No. TCD-8201C-2-2022

Japan Civil Aviation Bureau

Airworthiness Directive

1. Applies to: Kawasaki BK117 series helicopters equipped with a Goodrich rescue hoist assembly having a Part Number (P/N) as listed in Table 2.1 of this AD.

Figure 1

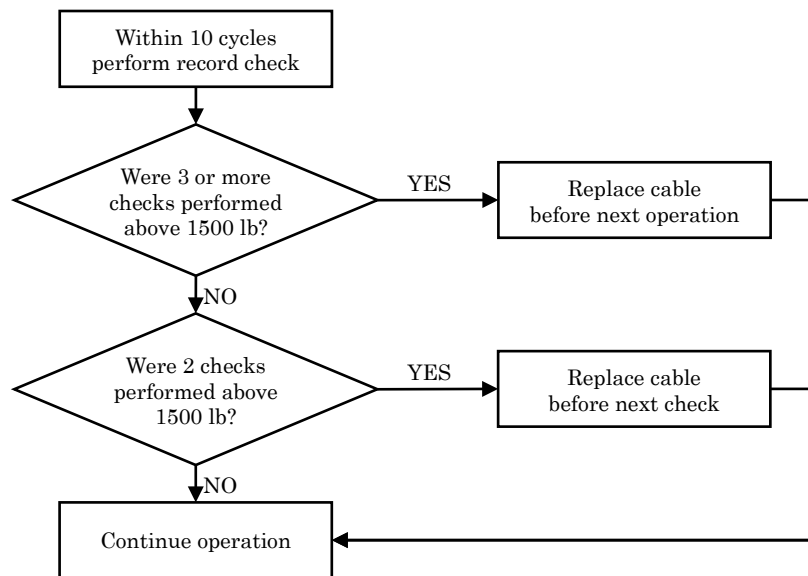
2.1 Within 10 hoist operating cycles from June 17, 2016 (the effective date of AD No. TCD-8201C-2016), accomplish a records check to determine whether, during any previous hoist load check/test, a cable was load-tested (average of 5 pulls) at 1500 lb [680 kg] or more. If any cable is identified to have exceeded this limit during two or more hoist load checks/tests, replace the affected cable with a serviceable cable within the time interval shown in paragraph 2.1.1 or 2.1.2 of this AD. For replacement of a cable, see Figure 1 of this AD.

2.1.1 If any cable is identified to have exceeded this limit during three or more hoist load checks/tests, before next hoist operation.

2.1.2 If any cable is identified to have exceeded this limit during two hoist load checks/tests, before the next hoist load check/test.
